MONMOUTH COUNTY DEVELOPMENT REVIEW COMMITTEE

Site Plan Action

Our File # HSP10385

known as Preliminary & Final Major Site Plan Sea Grass NJ, LLC

ATTACHMENT 1

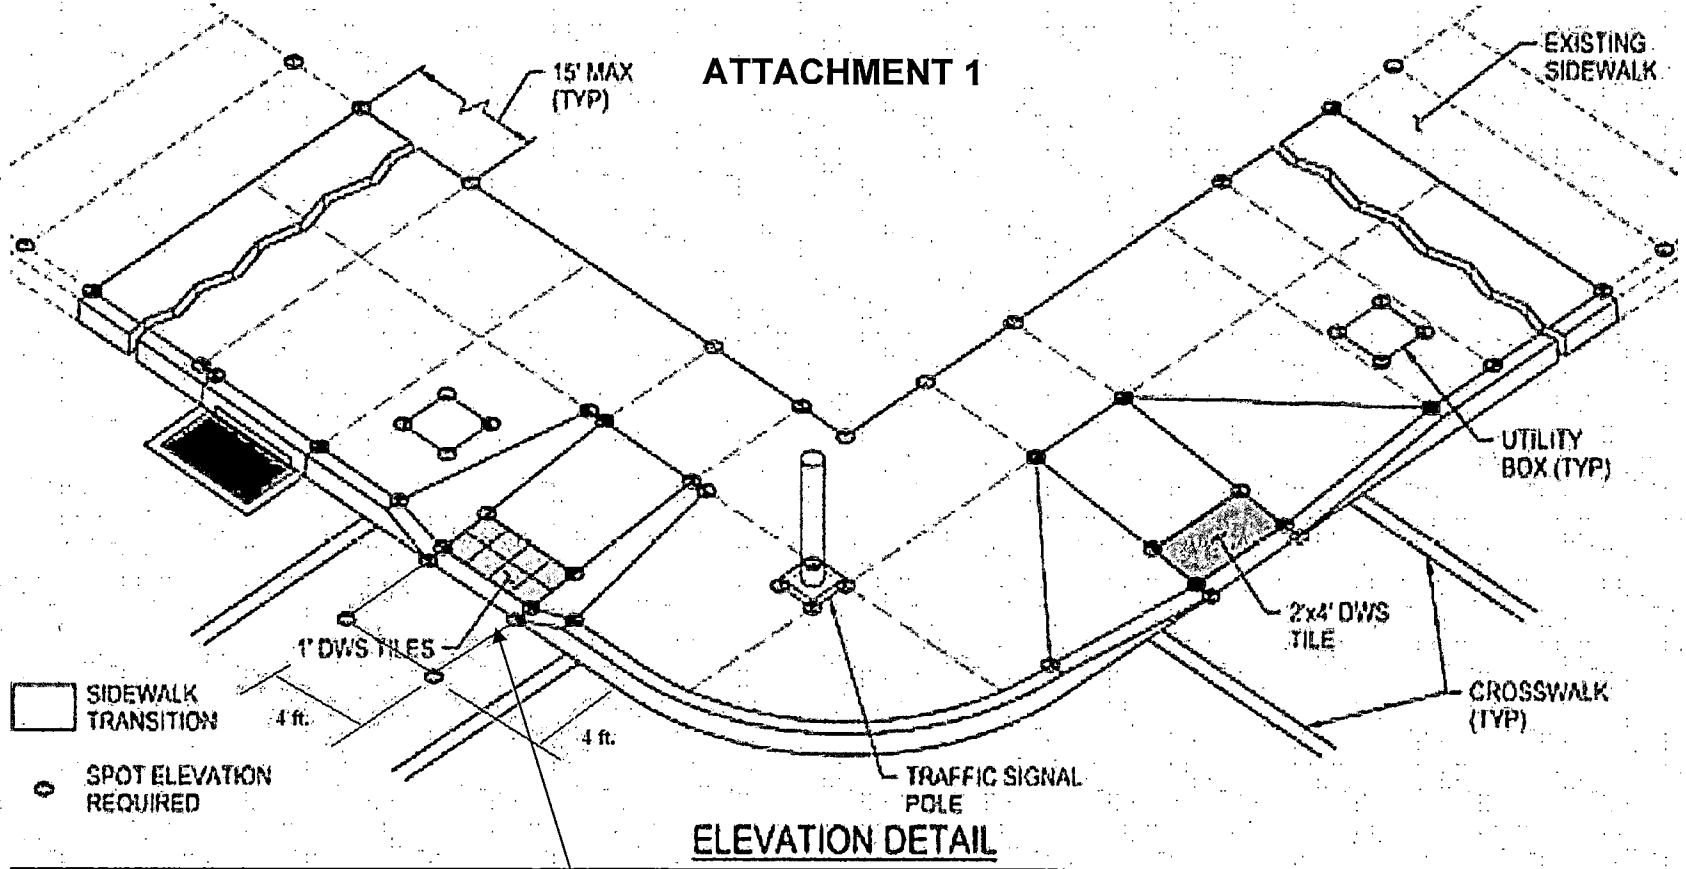
8. Provide grading details for the ADA ramps, at scale 1-in. = 6-ft. or greater. Provide the following information:
 - a. Provide spot elevations at top and bottom of all existing and proposed curb ramps; at corners of detectable warning surfaces, and associated landing / maneuvering areas; at corners of all transition areas, and at corners of ramp flares, as indicated on Attachment 1;

IF RAMP IS NOT DIRECTIONAL, MUST PROVIDE 4-ft. x 4-ft. TURNING AREA ON PAVEMENT, AT MAX. 2% SLOPE IN BOTH DIRECTIONS. SEE ATTACHMENT 2

ATTACHMENT 2

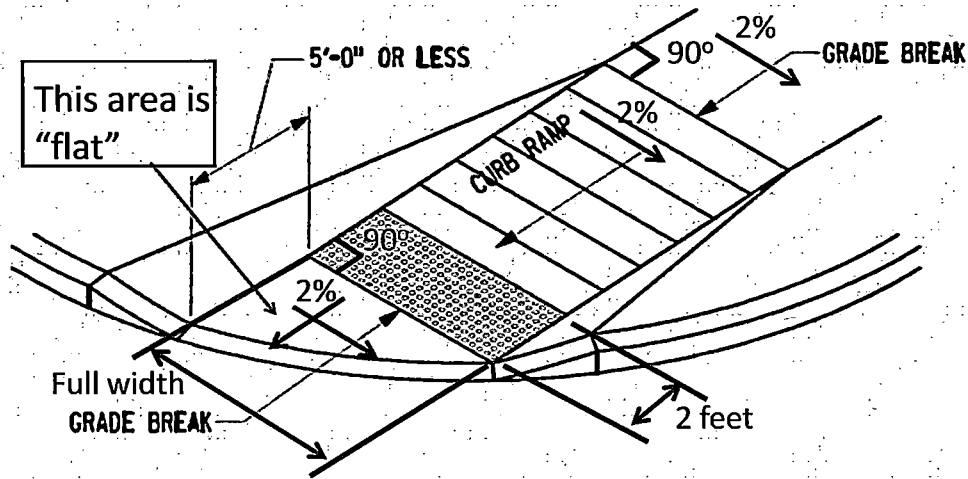
- b. Indicate clearly that all changes in longitudinal / running slope are perpendicular to the direction of the associated sidewalk and that all cross-slopes are at maximum 2%, as indicated in Attachment 2;

- Grade breaks perpendicular to direction of travel
- DWS place full width of curb ramp

ATTACHMENT 4

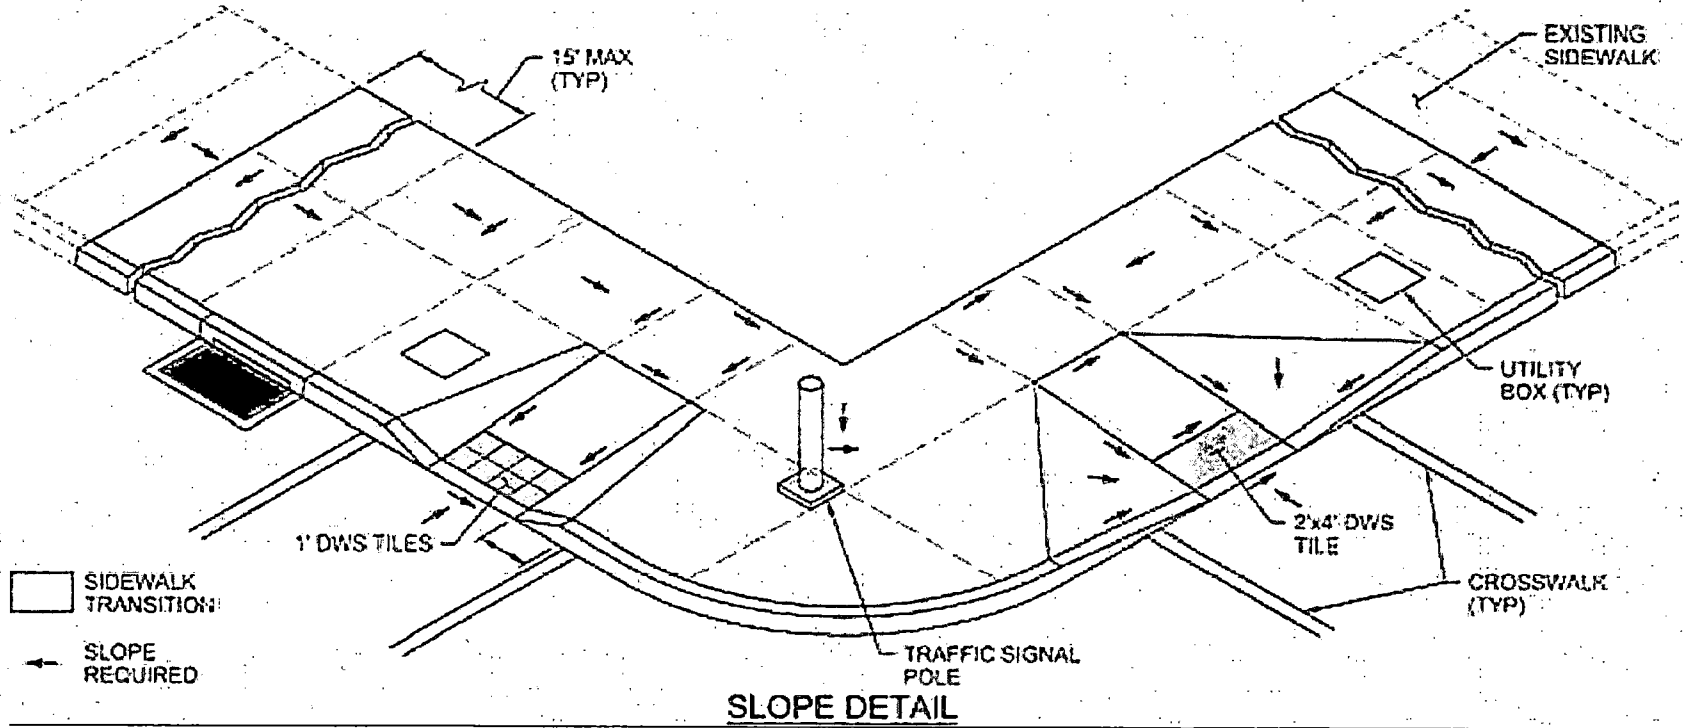
- 8.d. Provide computations to verify that all longitudinal / running slopes are at maximum 8.33% (1V:12H) and that all cross slopes are at maximum 2% at locations indicated on Attachment 4. Use design slopes of 7.0% and 1.5% respectively, to allow for construction tolerances;
- e. Indicate clearly that curb ramps within the right-of-way of C.R. 8, Bay Avenue., are aligned with crosswalks, as indicated in Attachment 5;
- f. If curb ramps are not aligned with crosswalks, provide 4-ft. x 4-ft. Turning Area with maximum 2% slope, as indicated in Attachment 6;

DROPPED CURB AND CRADLE

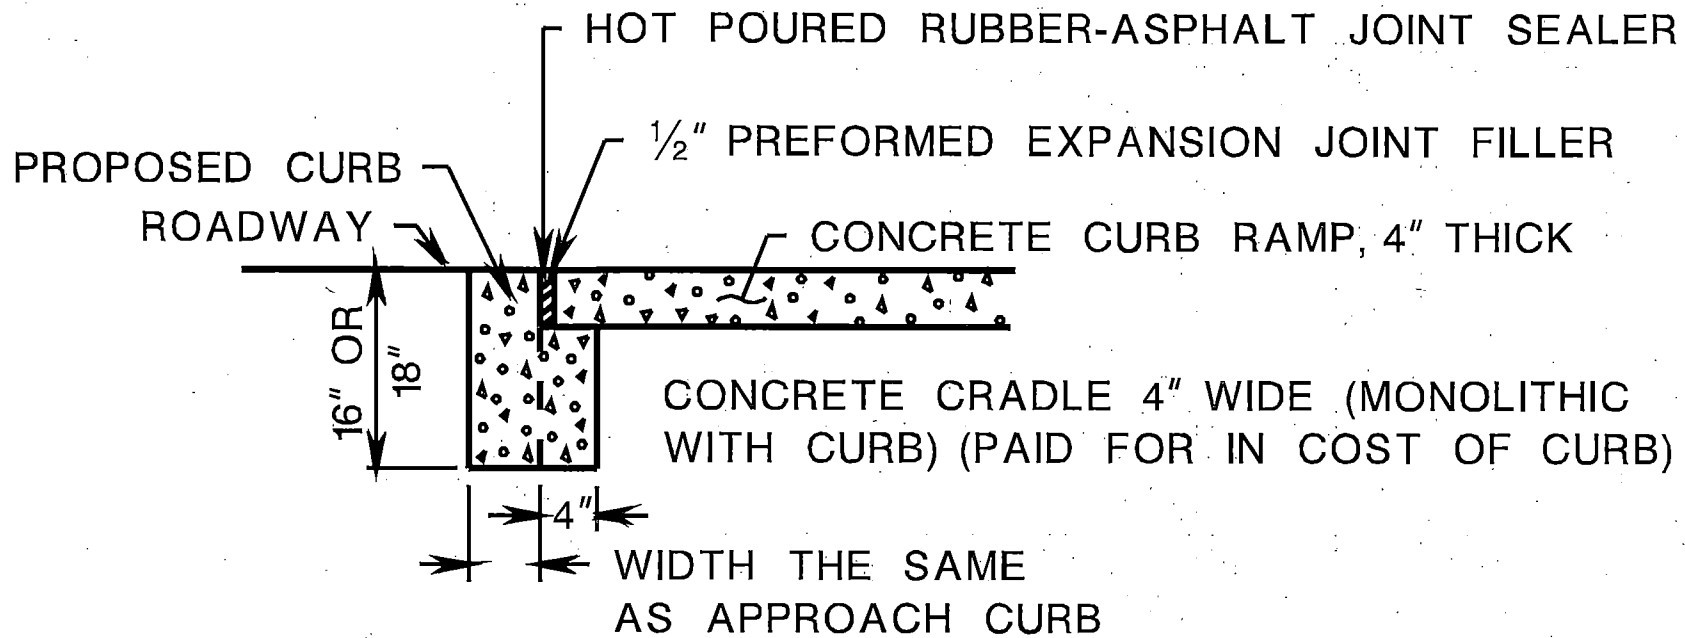
Incorporate the attached curb cradle detail into the detail sheet(s).
